## ArevaEPRDCPEm Resource

**From:** WELLS Russell (AREVA) [Russell.Wells@areva.com]  
**Sent:** Friday, July 29, 2011 4:59 PM  
**To:** Tesfaye, Getachew  
**Cc:** ROMINE Judy (AREVA); LENTZ Tony (EXTERNAL AREVA); WILLIFORD Dennis (AREVA); BENNETT Kathy (AREVA); DELANO Karen (AREVA); RYAN Tom (AREVA)  
**Subject:** Response to U.S. EPR Design Certification Application RAI No. 371, FSAR Ch. 3, Supplement 23  
**Attachments:** RAI 371 Supplement 23 Response US EPR DC.pdf

The attached file, "RAI 371 Supplement 23 Response US EPR DC.pdf" provides a REVISED technically correct and final response to Question 03.07.02-68 to address NRC comments. Appended to this file are the affected pages of the U.S. EPR Final Safety Analysis Report in redline-strikeout format which support the response to RAI 371 Question 03.07.02-68.

**Question 03.07.02-68:**

**Figure 3.7.2-68-1—MTR/SASSI Excavated Soil Model  
(Governing Element Lengths within RBIS)**

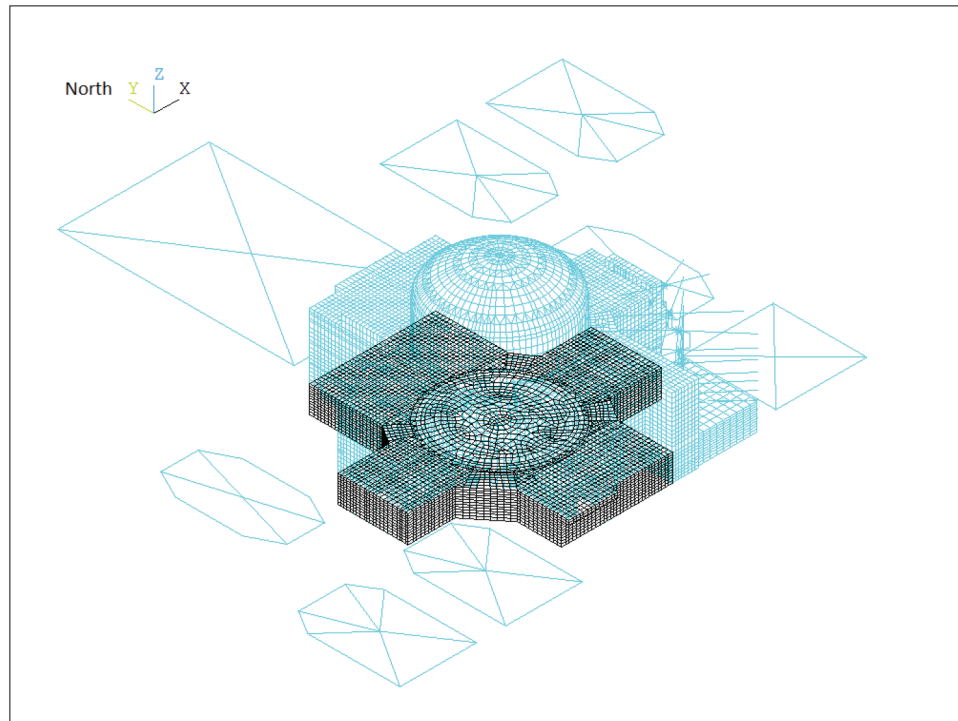
Figure 3.7.2-68-1 shows the MTR/SASSI excavated soil model. The model shows element sizes for the Reactor Building Internal Structures (RBIS), Safeguard Buildings (SB), and Fuel Building (FB). The RBIS mesh is coarser than the mesh for the SB and FB structures. The RBIS mesh governing element size is approximately 3.0 m. Table 3.7.2-2 and Figure 3.7.2-68-2 summarize the cumulative modal mass participation for the fixed base NI finite element model from ANSYS.

**Figure 3.7.2-68-5—Center of Nuclear Island Basemat, In-Structure  
Response Spectra, Z-Direction, 5% Damping**

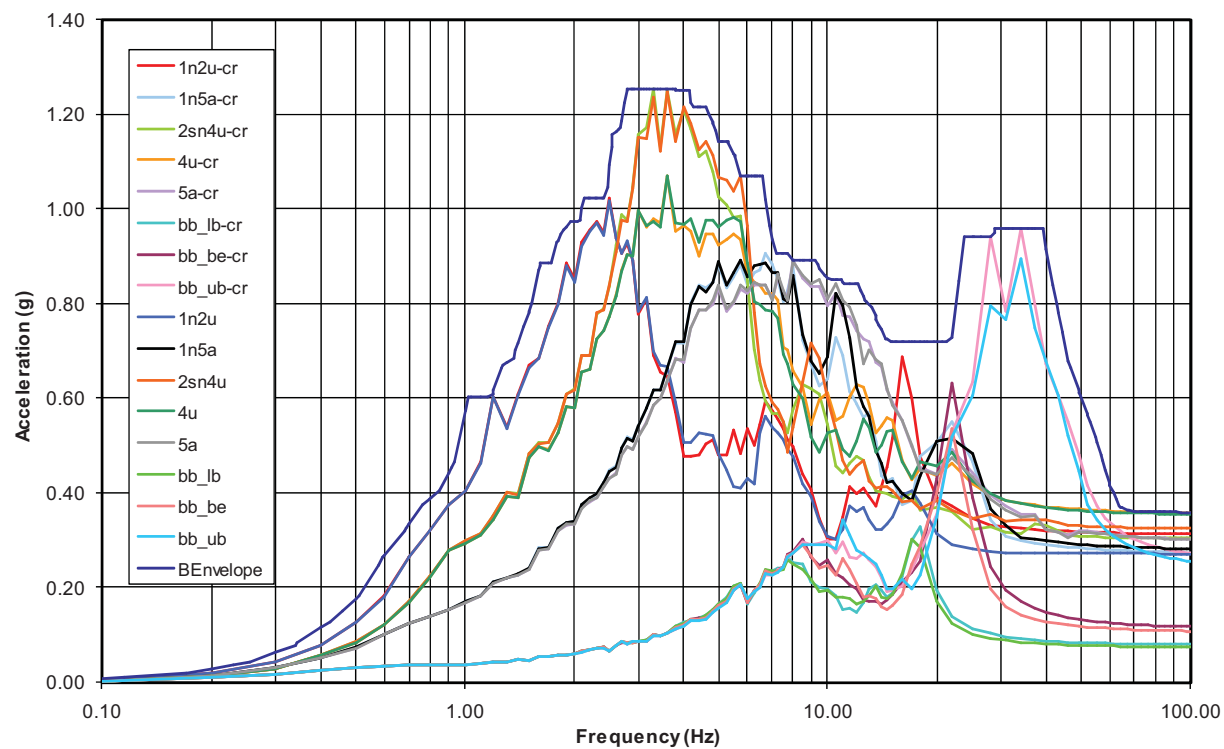
- For soil case 1n2ue-s (very soft soil case), the frequency range of interest is below 3 Hz as shown in the NI basemat in-structure response spectra (ISRS), as shown in Figure 3.7.2-68-3 through Figure 3.7.2-68-5. As a result, the dominant soil-structure frequency is well below 14 Hz, and no significant structural response is associated with a frequency beyond 14 Hz. Table 3.7.2-68-2 shows the mass participation for the fixed base case. In the two horizontal directions, a mass ratio of approximately 80 percent is considered with the fixed-base model modes up to 14 Hz. A greater mass ratio is considered for the relatively soft soil case 1n2ue-s.

**Figure 3.7.2-68-A5—Comparison of Subtraction and Direct Analysis Method  
for the Simplified Coarse and Refined ESWB, Flexible Node 21837,  
X-Direction, Soil Case 12URB\_LB**

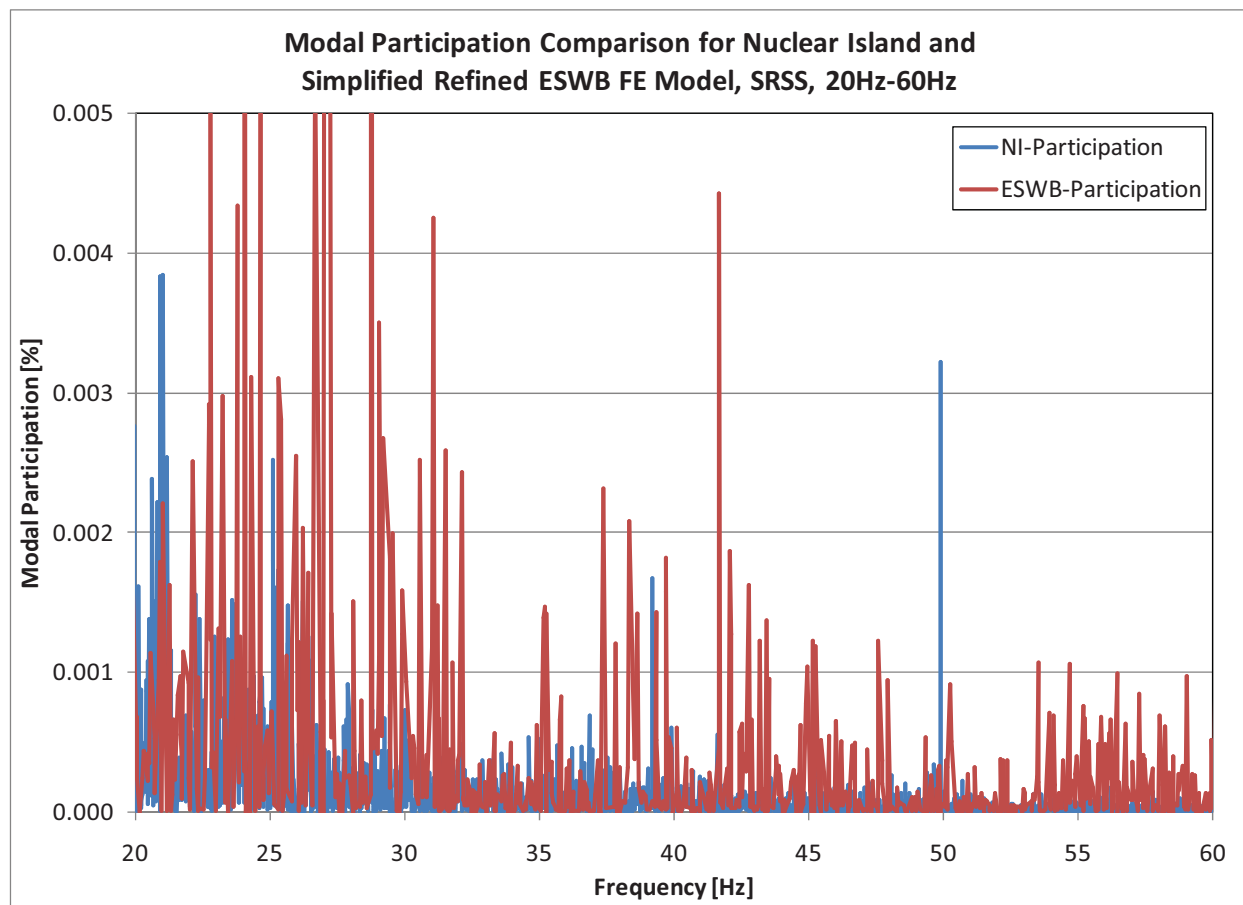
The formula for  $f_{\max}$  was confirmed in the sensitivity study, as shown in Table 3.7.2-68-A1, and in Figure 3.7.2-68-A5 through Figure 3.7.2-68-A7. When compared to the coarse model with the direct method, and the refined model with the subtraction method, the accuracy of the responses from the 12URB\_LB coarse simplified ESWB starts to deteriorate beyond the passing frequency of 19.8 Hz, when analyzed by the subtraction method.

**Figure 3.7.2-68-B3—Refined Mesh of the Basemat**

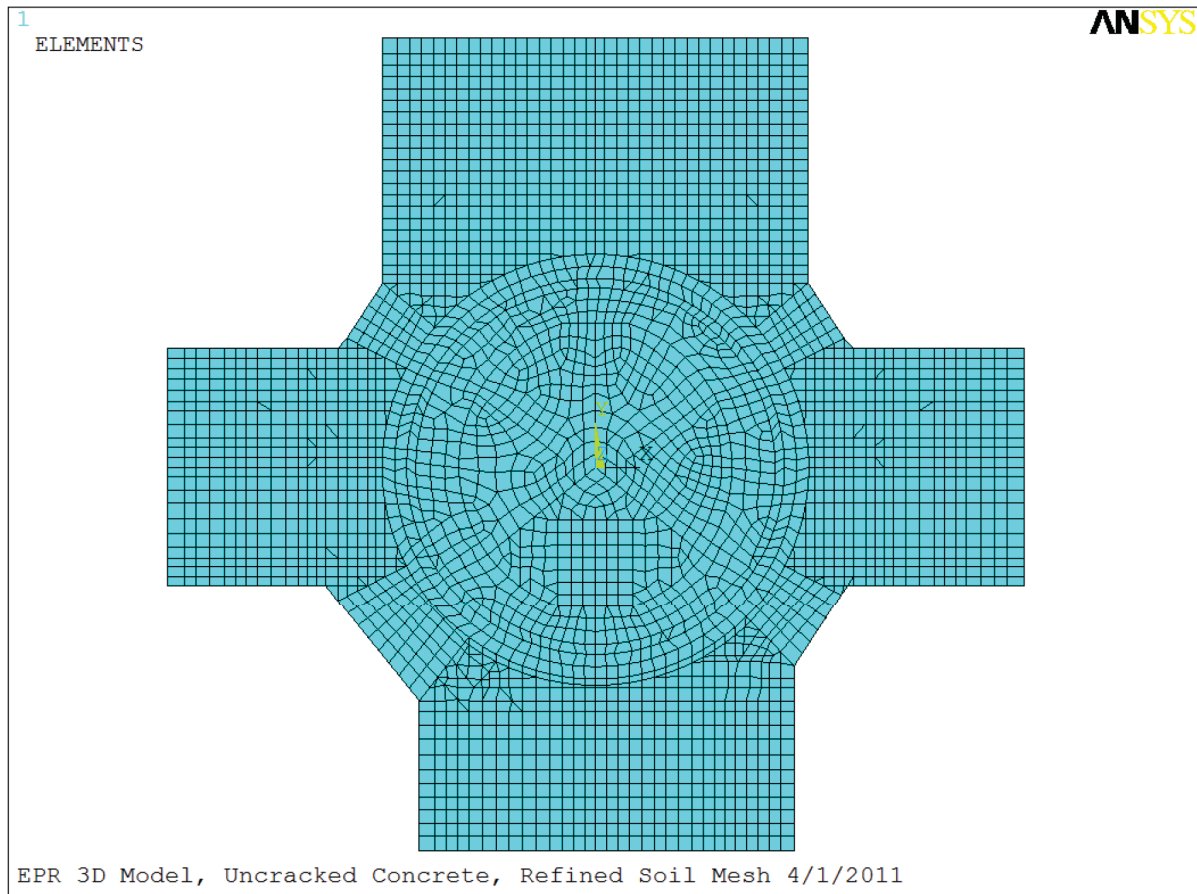
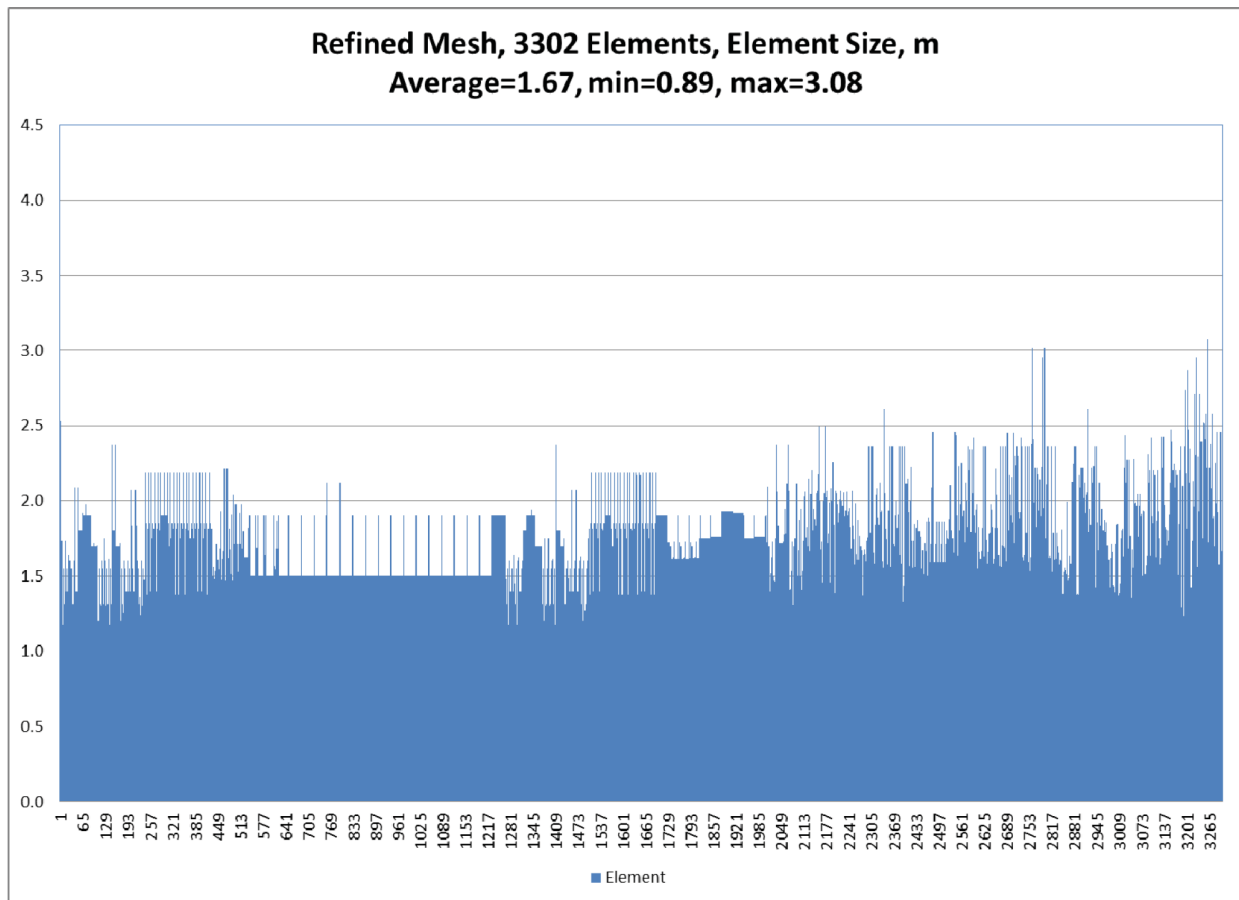
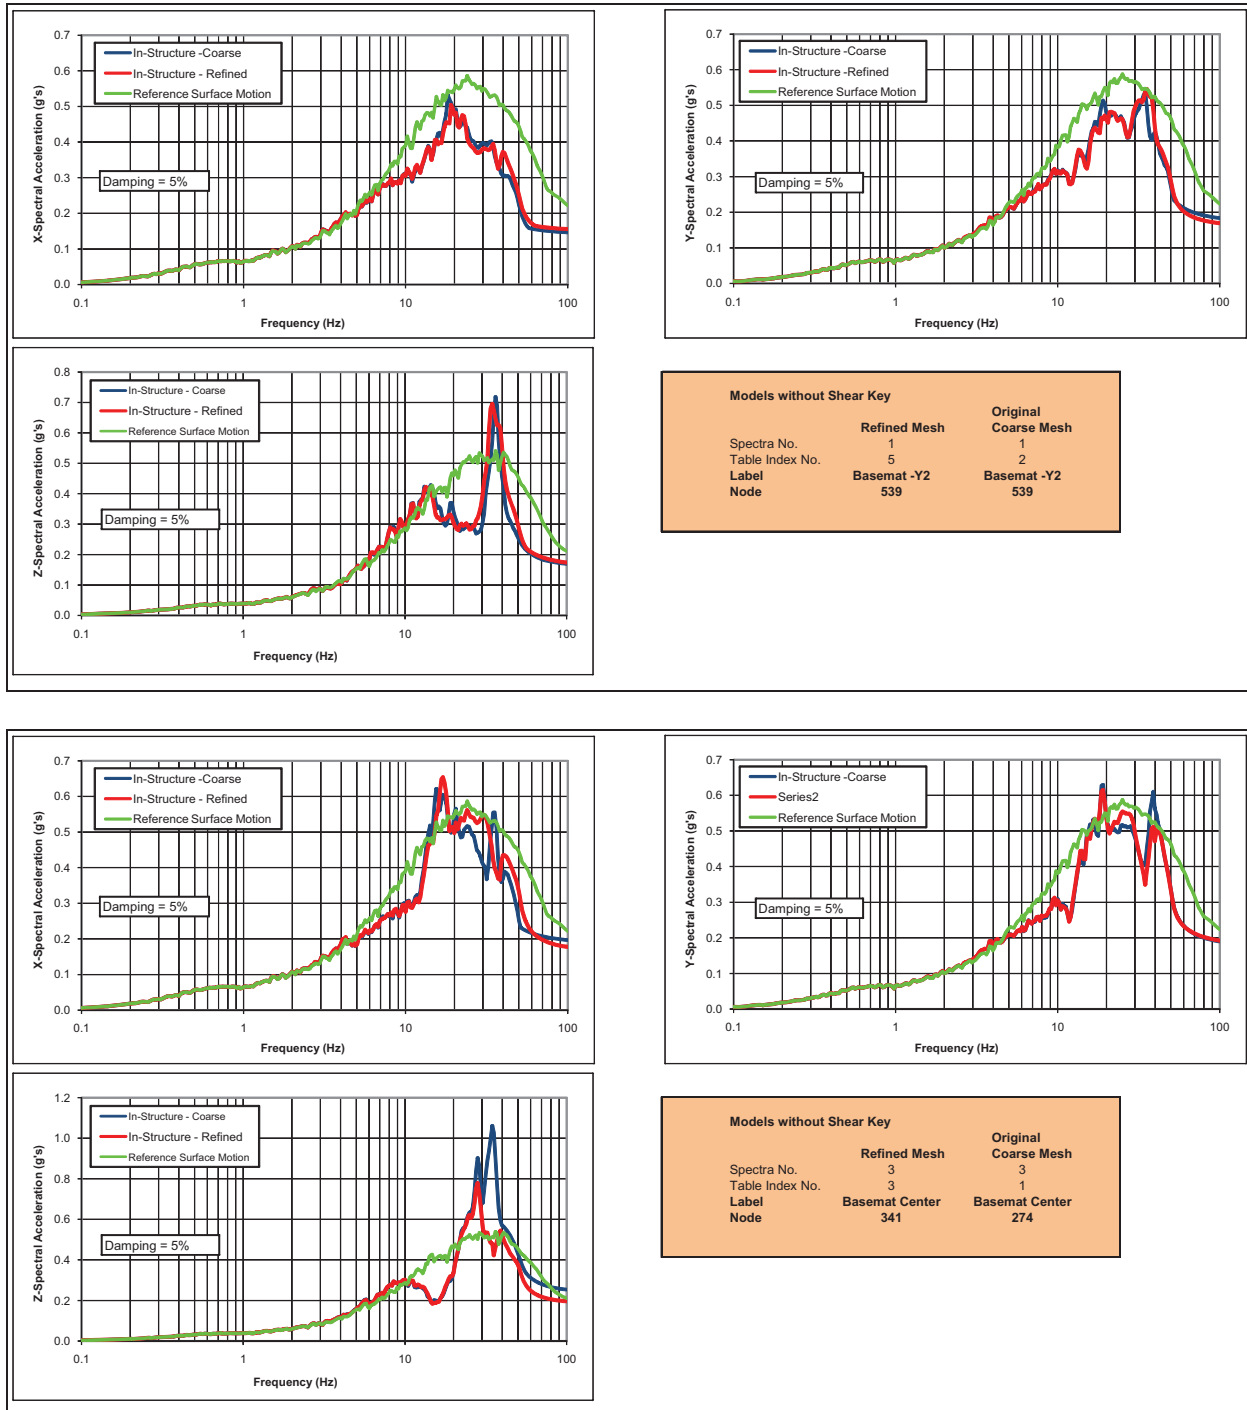
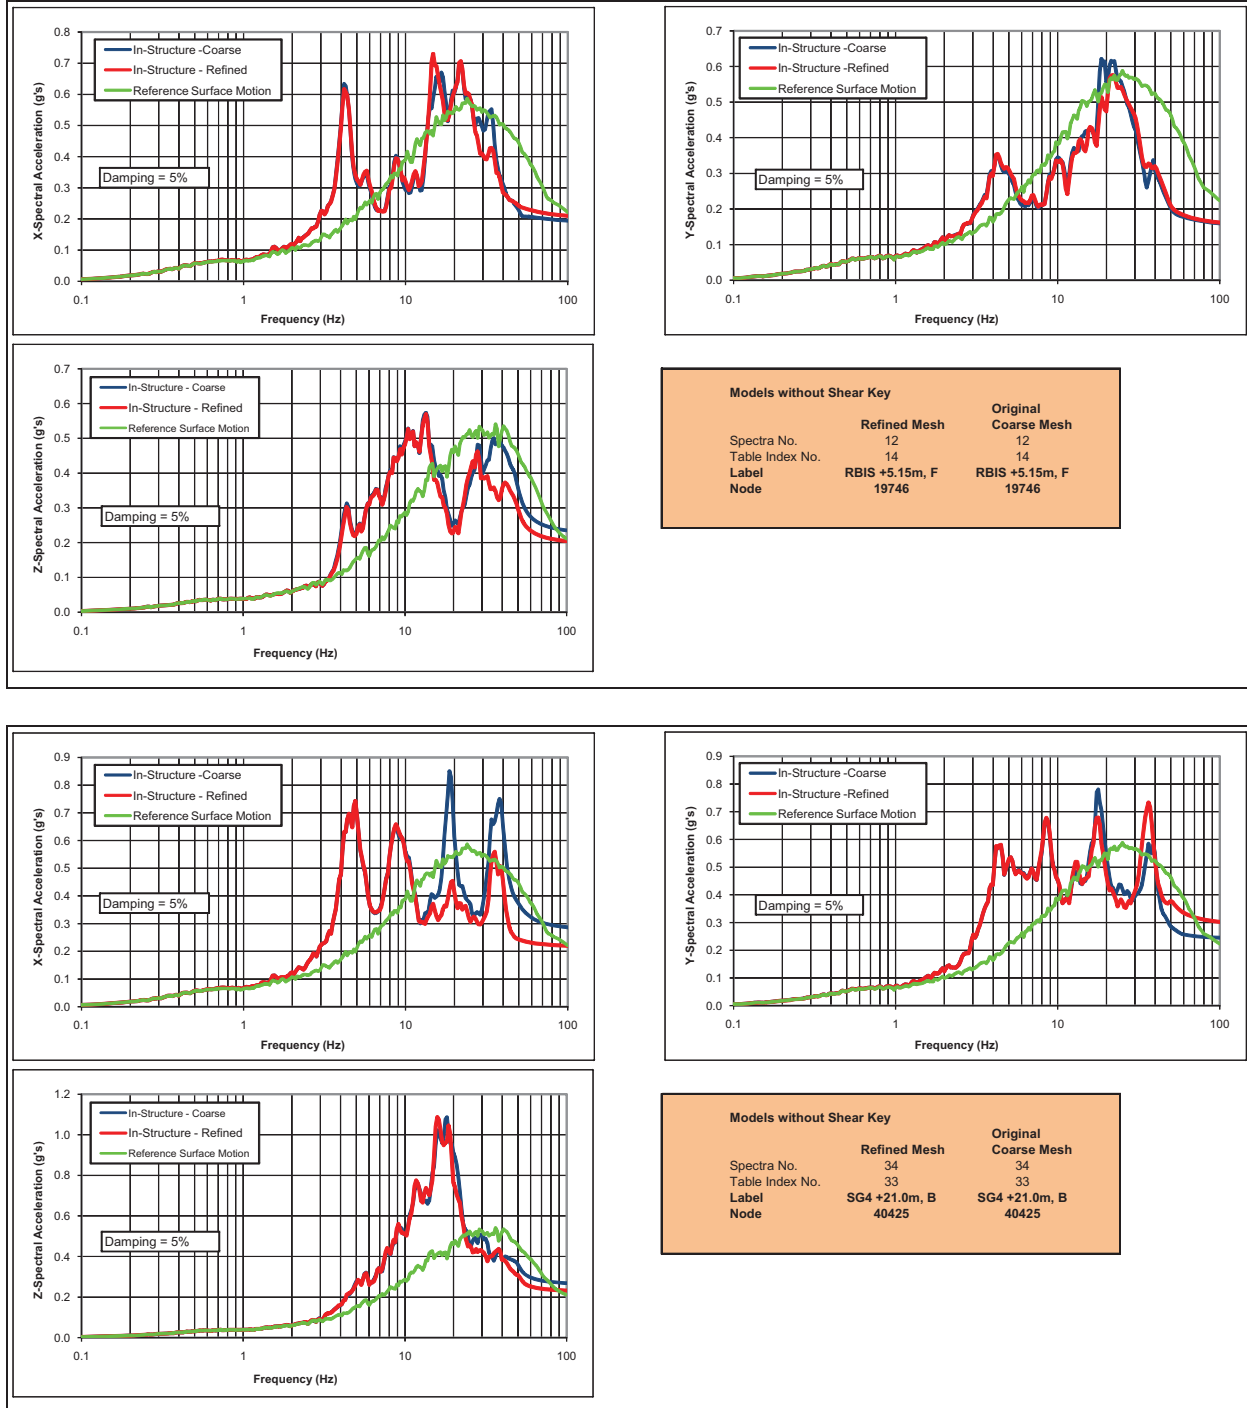
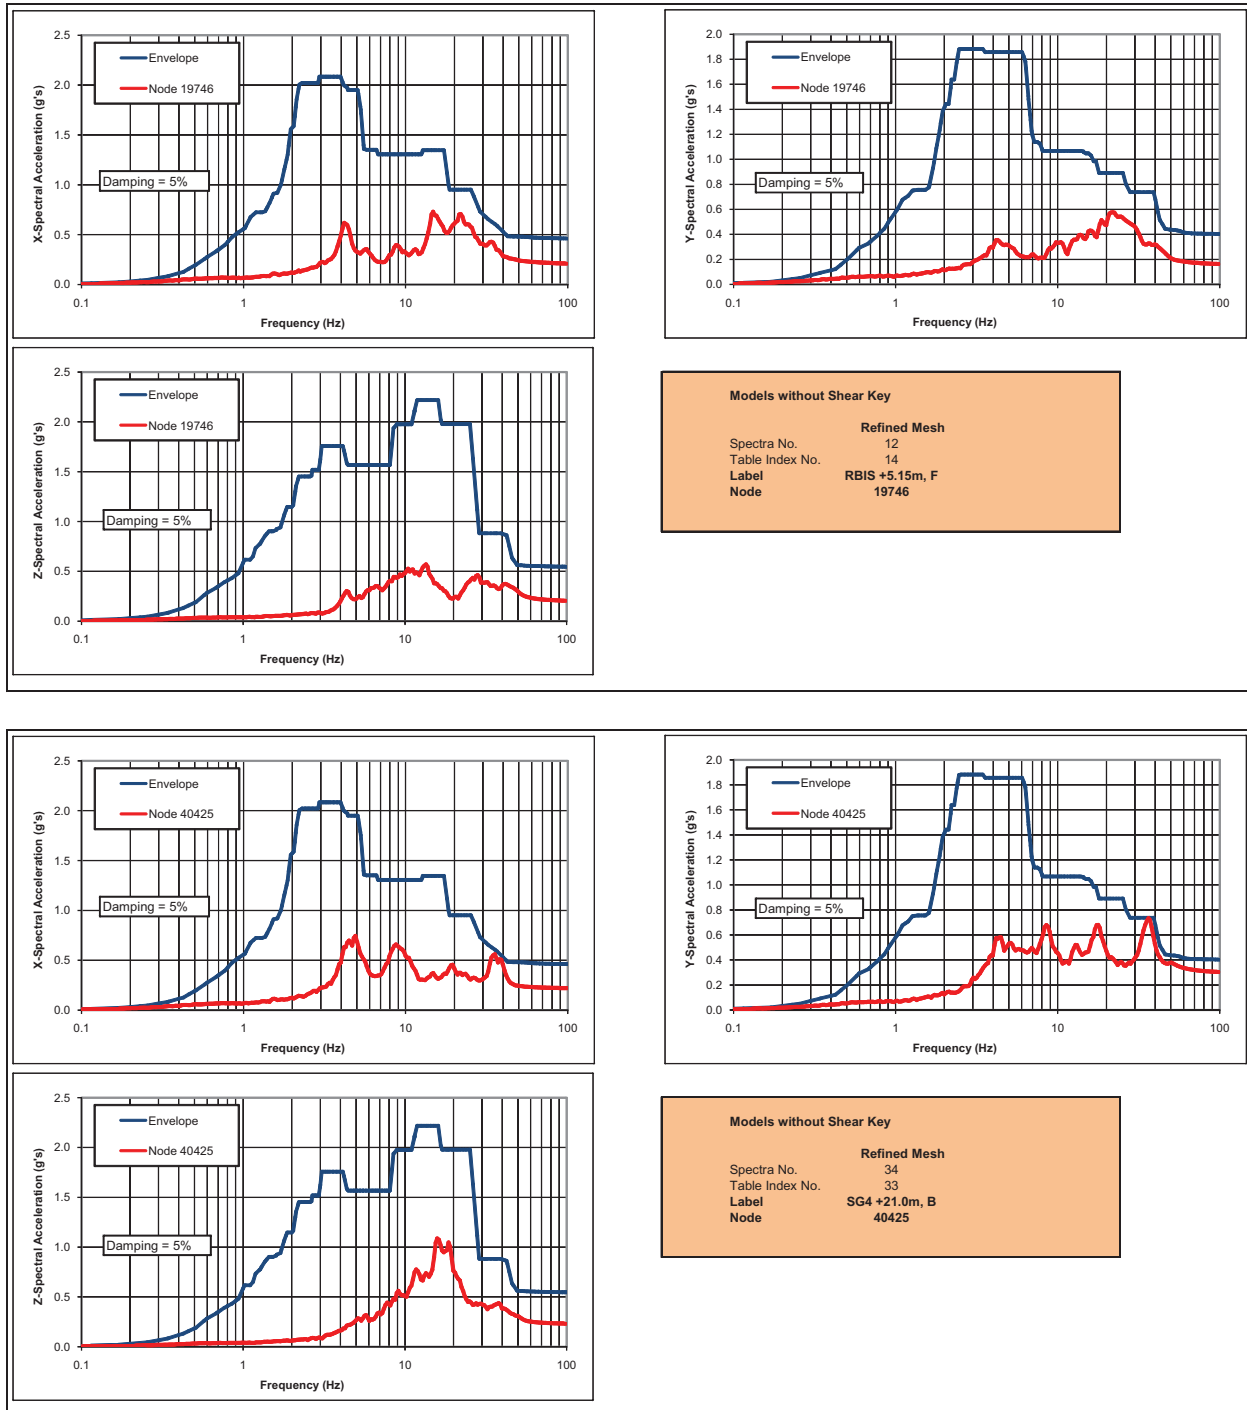
The finite element mesh in the central portion of the Nuclear Island (NI) basemat is further refined to determine the high frequency transmittal capability of the original NI model. The Bell Bend ground motions have a high frequency content that is considered in the U.S. EPR design. The refined soil-structure interaction (SSI) model is used to demonstrate that the original model can adequately transmit frequencies up to 50 Hz to capture high frequency contents of the Bell Bend input motions. Figure 3.7.2-68-B1 shows that the finite element mesh in the basemat is refined except in the central area. Figure 3.7.2-68-B2 shows that the mesh size is mostly 1.5 m outside the central area. In the central area, the average horizontal mesh size is approximately 3.0 m. For the Bell Bend upper bound soil case, with backfill shear wave velocity equal to 429 m/s, the passing frequency is approximately  $429/5/3 = 28.6$  Hz, which is less than the required 50 Hz.

The mesh refinement is performed on the central area of the basemat. The refined mesh is shown in Figure 3.7.2-68-B3. Figure 3.7.2-68-B4 shows that the average mesh size in the central area is 1.75 m. The passing frequency is approximately  $429/5/1.75 = 49.0$  Hz. The SSI model for the refined mesh did not include the shear key as a result of program size limitations. Therefore, for comparison, an equivalent NI model with the original mesh without the shear key was developed from the existing model so that the effects of the mesh size could be assessed. Both models were analyzed for the Bell Bend upper bound soil and input motions.

The NI SSI model, with the original and refined basemat meshes, was analyzed for the Bell Bend upper bound soil case and input motions. The five percent damped in-structure response spectra (ISRS) at several key locations in the structure are computed from the original and refined mesh models and compared in Figure 3.7.2-68-B5. The spectra from the refined mesh model compare very well with or are less than those of the original mesh model with the exception of a few exceedances. Figure 3.7.2-68-B6 shows that these exceedances match or are bounded by the peak-broadened envelope design spectra. Overall, the original mesh adequately captures the seismic response of the NI.
